RESOLUTION OF THE LOCAL PLANNING AGENCY
THE TOWN OF FORT MYERS BEACH, FLORIDA
RESOLUTION NUMBER 2012-005
EAGLE EQUITY CAPITAL CPD

TYPE OF CASE: Commercial Planned Development (CPD)
CASE NUMBER: FMBDCI2012-0001
LPA HEARING DATE: April 10, 2012
LPA HEARING TIME: 9:00 AM

Request: Commercial Planned Development (CPD) Amendment to expand the existing CPD, formerly known as Big John's Board Walk Eatery, which was approved per Resolution No. 06-30, to allow for required parking on-site for the existing restaurant uses, in addition to stormwater management, and landscape buffers.

EAGLE EQUITY CAPITAL LLC
MASTER CONCEPT PLAN
 FORT MYERS BEACH, FLORIDA

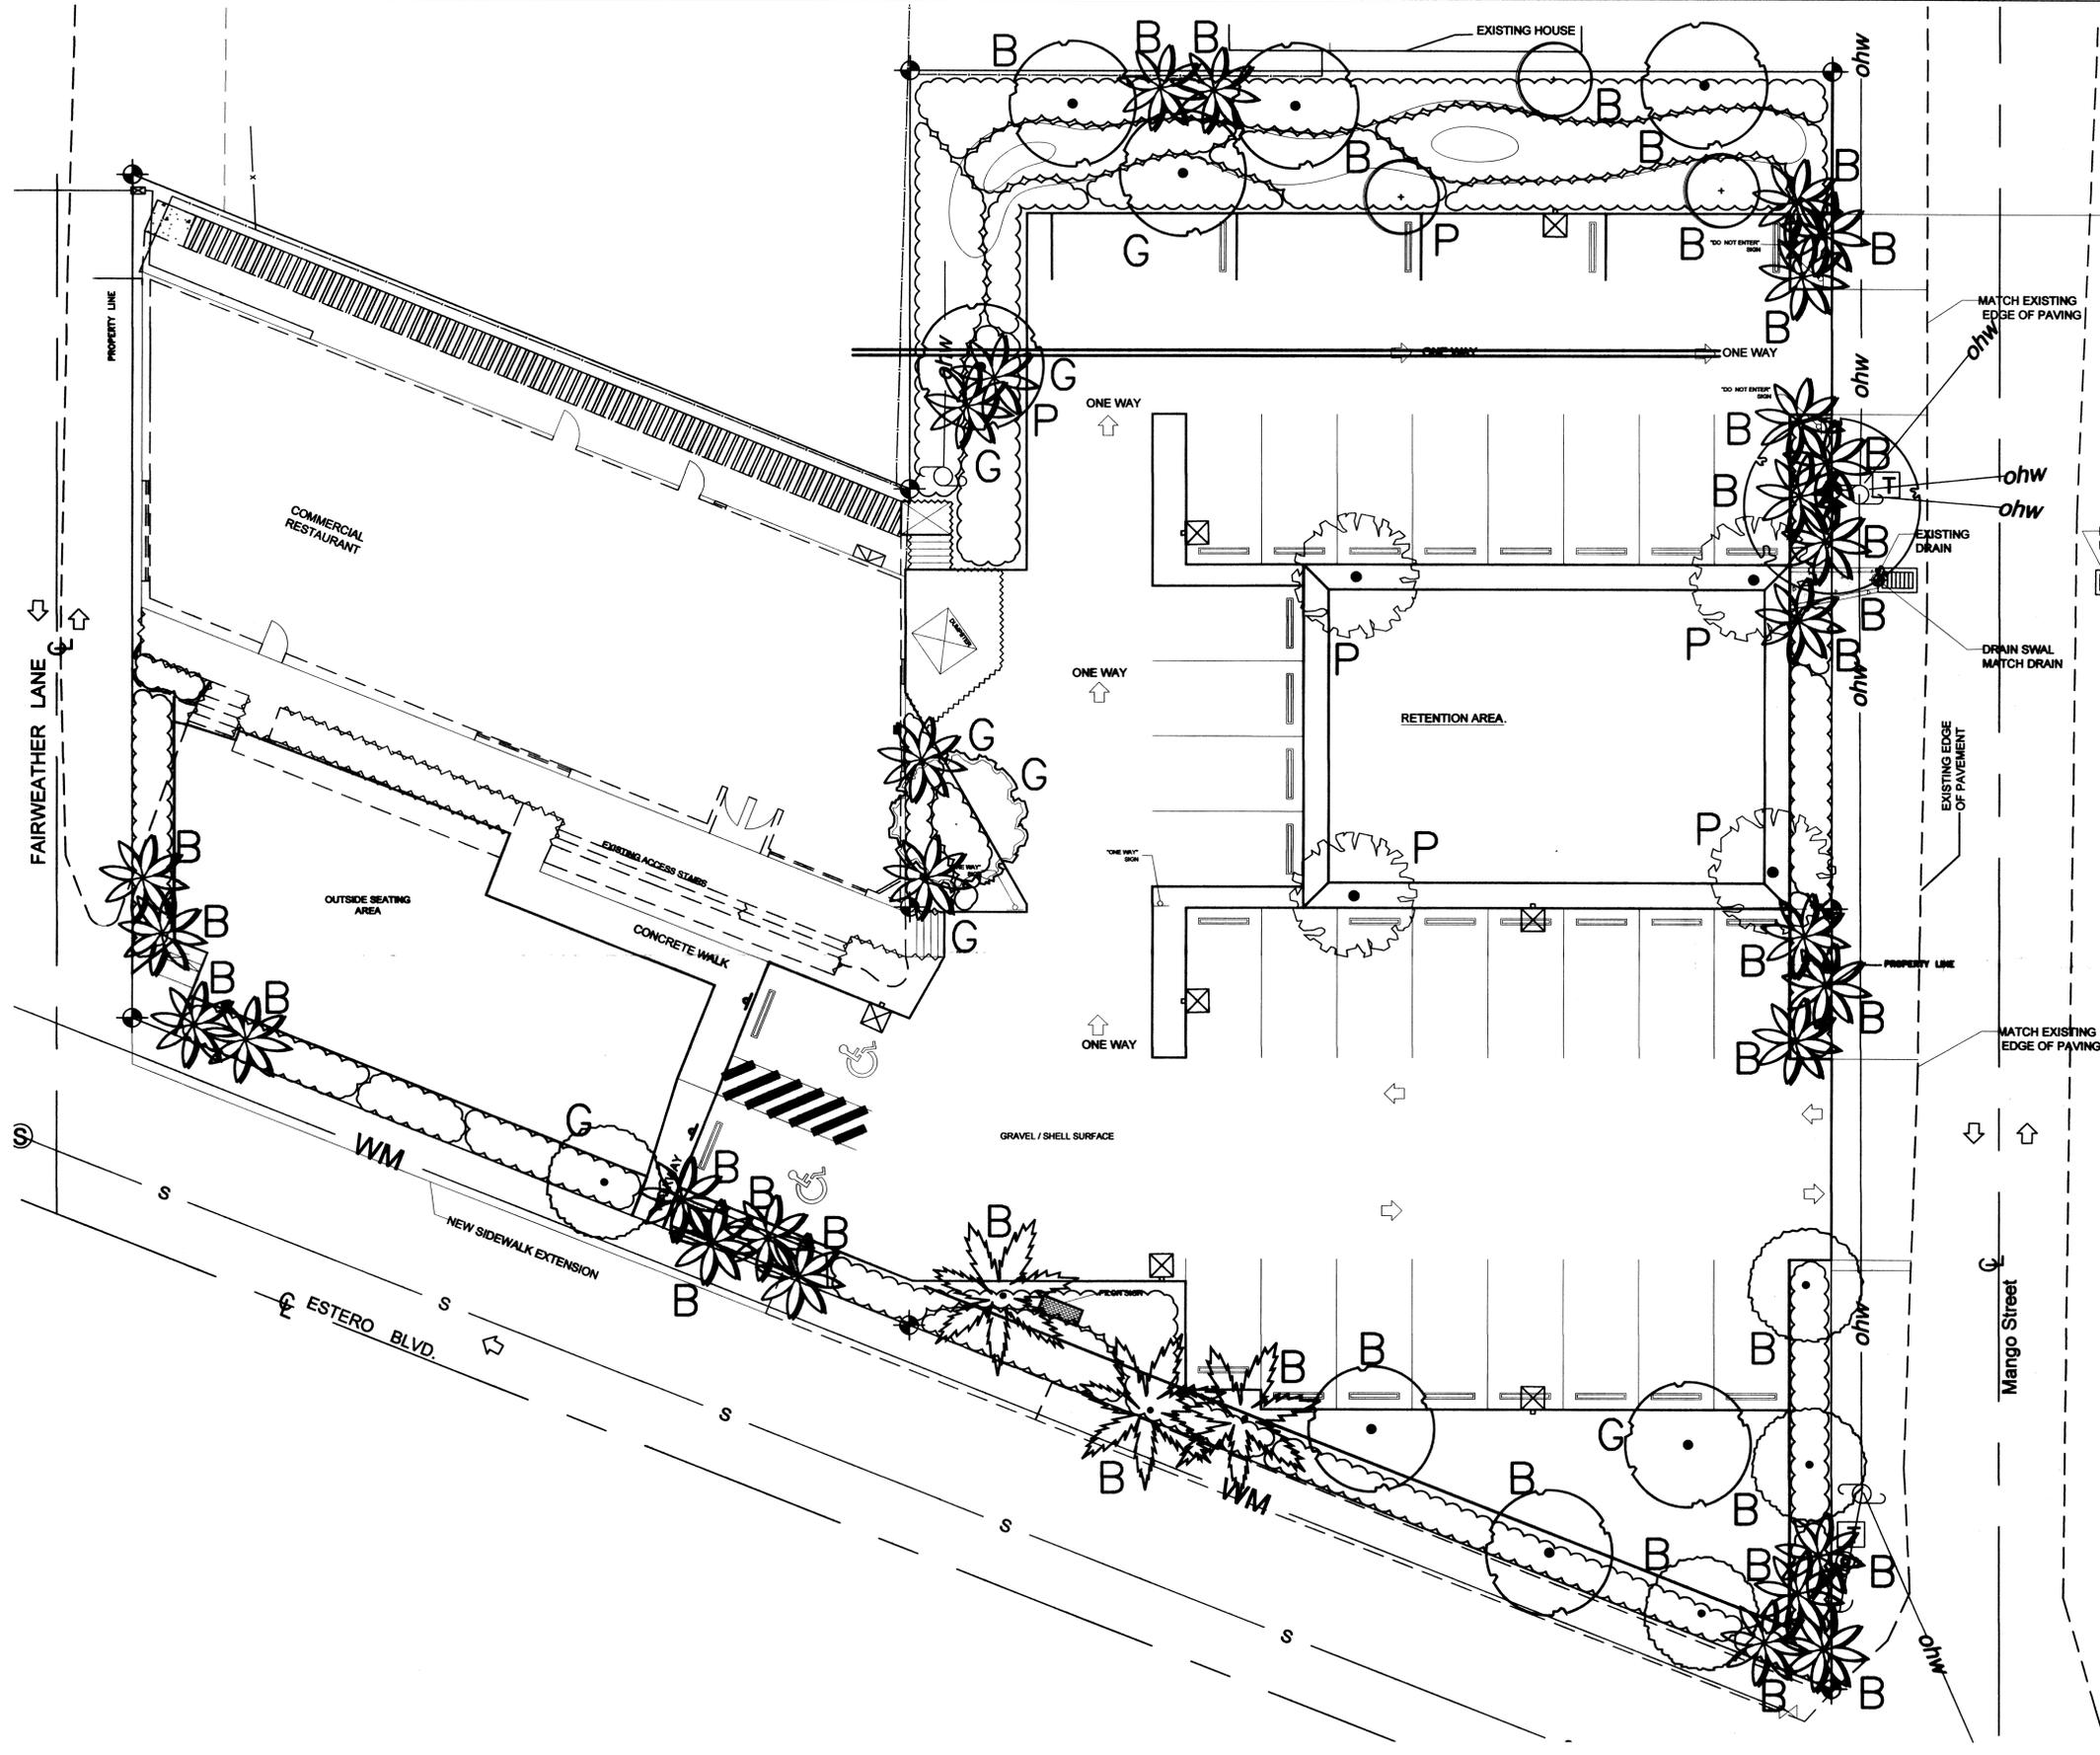
Staff recommends APPROVAL of Deviation #2, because the request has no detrimental impact on the public interest and enhances the objective of the proposed planned development. Approving a reduction in required buffer widths is a mutually beneficial compromise as it allows for the most efficient use of the subject property and requires an aesthetic improvement to the Estero Boulevard and Mango Street road frontages. It should be noted that approval of this deviation does not include a reduction in required plant material; 5 trees per 100 linear feet and a double row hedge maintained at 36" will still be required along the Estero Boulevard and Mango Street frontages. Please see Exhibit B, for an illustrative landscape plan.

Exhibit D-1-F Schedule of Deviations & Justification

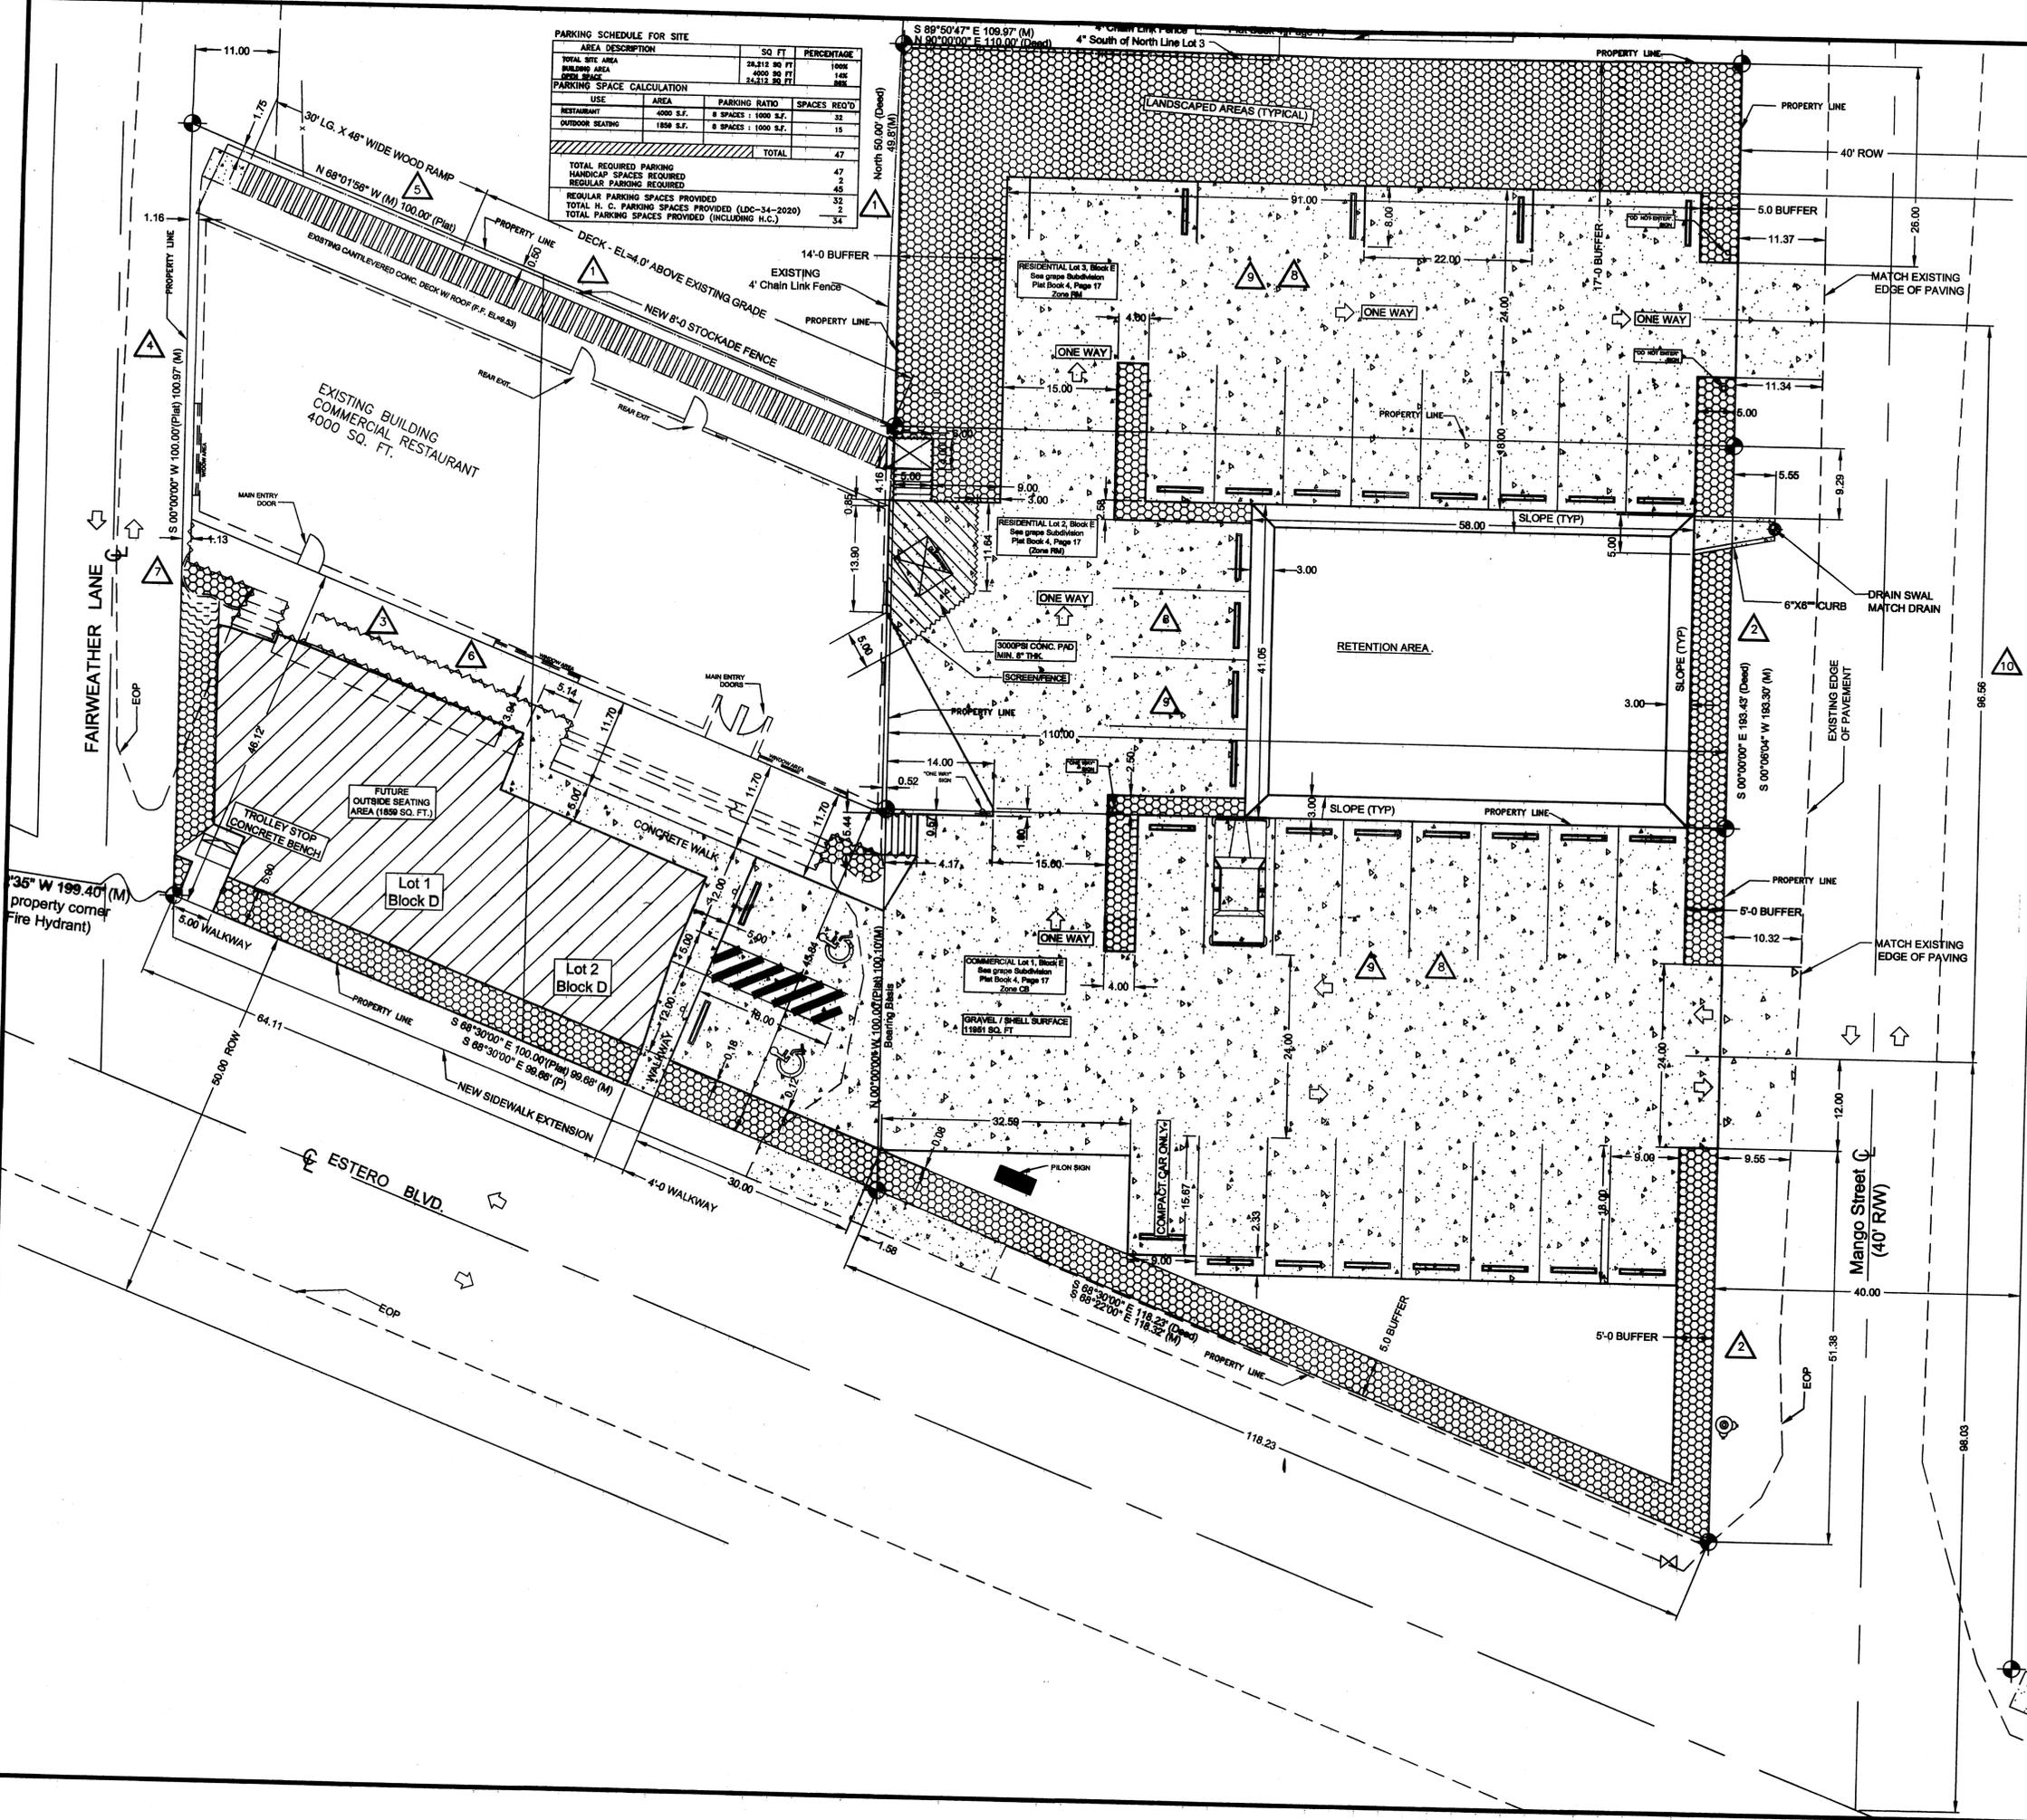
RESPONSE: Please refer to the revised Master Concept Plan (MCP). The locations of deviations are shown and numbered in accordance with the Schedule of Deviations and Justifications (attached as Exhibit D-1-F).
